File: 18782-011-00

Subject: Landslide Hazard, Vicinity of Little Missouri River Crossing,
Dakota Access Pipeline Project, North Dakota

Landslide Complex MP15 - MP18
 Proposed DAPL Main Line
 North Dakota, South Dakota, Iowa, Illinois

Figure 1

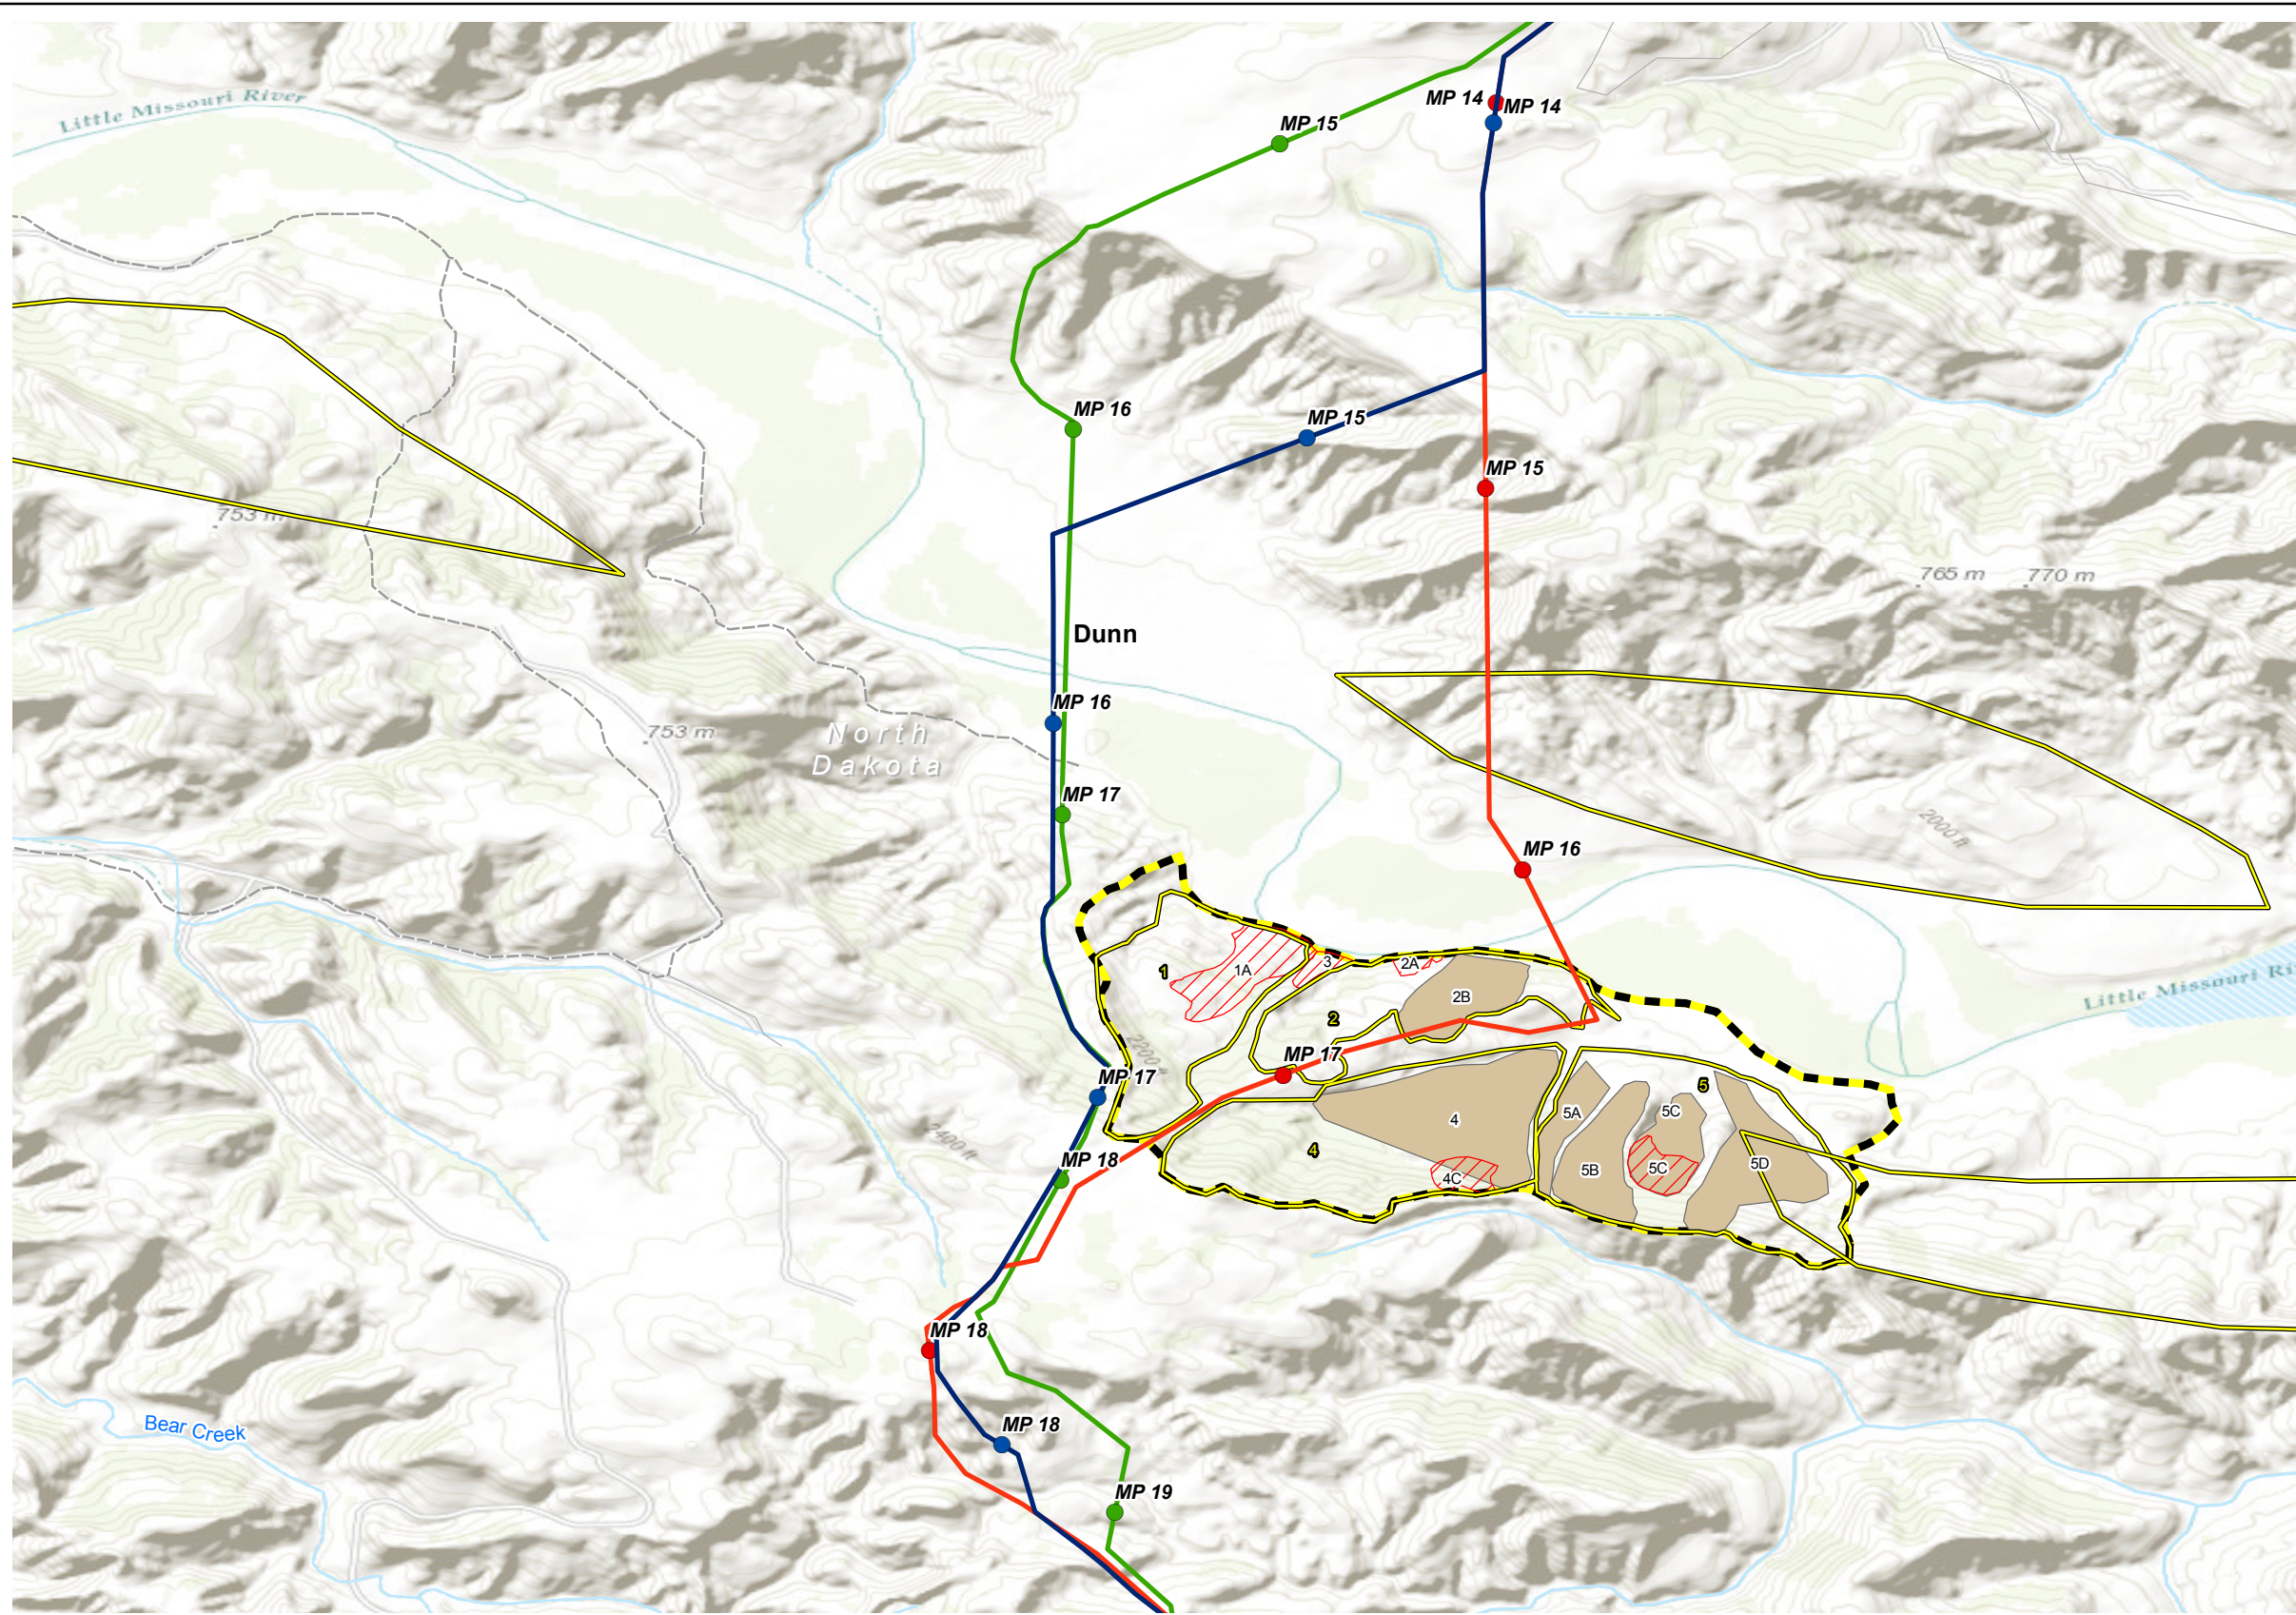
Our work included both desktop review of geology and landslide mapping, and field reconnaissance evaluations of the active landslides. We also assessed geologic risk in the vicinity of an alternate alignment (July 10, 2014 route, shown in green in Figure 1) and concluded that the ground in the vicinity of this alternate alignment appeared stable to the south of the Little Missouri River but crossed landslide-prone areas north of the river. Based on the results of our engineering and geological evaluations, and other considerations, the "current" DAPL alignment was developed (December 12, 2015 alignment, shown in blue in Figure 1).

As shown in the attached Figure 1, the current DAPL route avoids the area of active and historic landslides (the "landslide complex"), south of the Little Missouri River. Further, the current route is located within a separate slope, as divided by topography and drainage areas; this separation limits risk of active landsliding impacting the current route. The steep slopes along the proposed alignment north of the river will be crossed using horizontal directional drilling. Accordingly, we judge the landslide risks to the current route to be low. Please refer to the above referenced memorandum for detailed engineering and geology analysis and discussion of the referenced geologic features.
